ARTWORK APPROVAL

PSM/PSP – PSP-000-1964

AW006201 **Version 01**

ALGO TUBE GEL EXF.MARIN DOUCEUR
30ML1120 (210726)

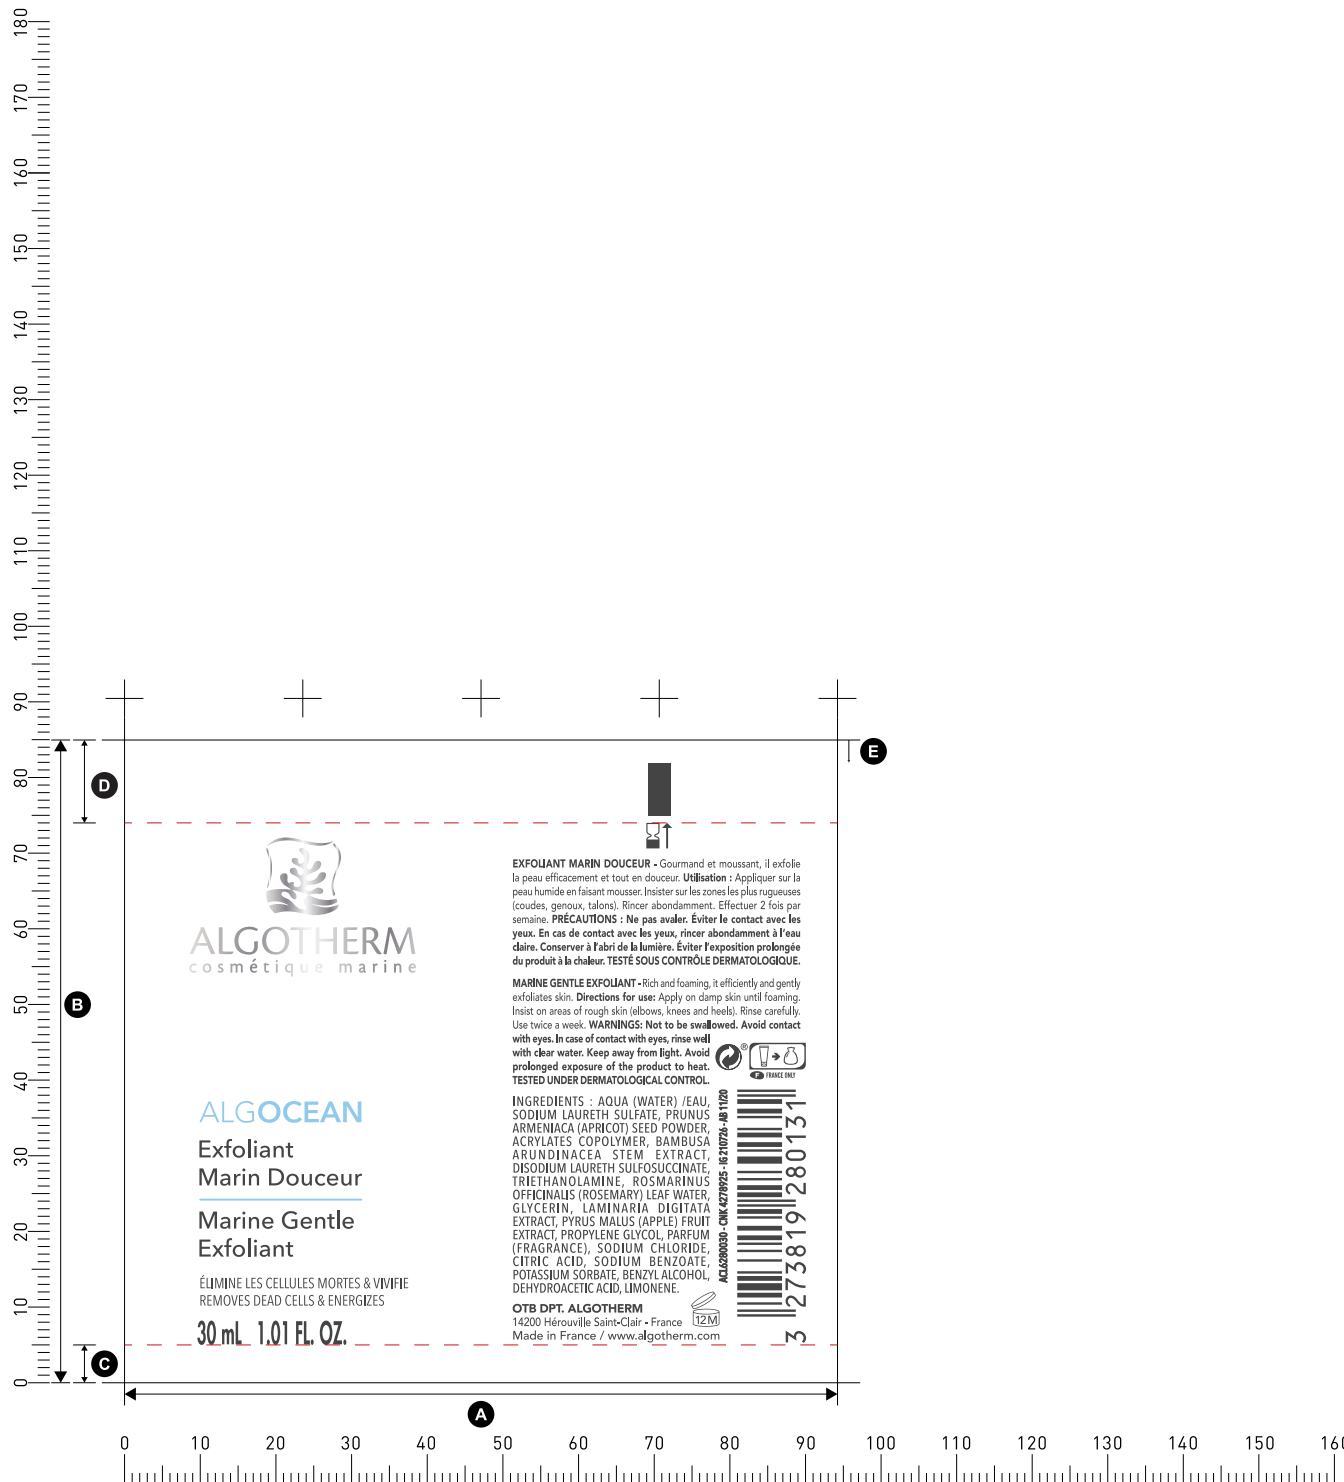
VER	DATE	COMMENT
01	28-12-2020	1. AS per received file we centre align both artwork.

Note:- "If no print at open end is less than 10MM there is chance of ink cracking while sealing of tube (depends upon colour of sleeve and ink), we suggesting there should be a sealing test before commercial printing"
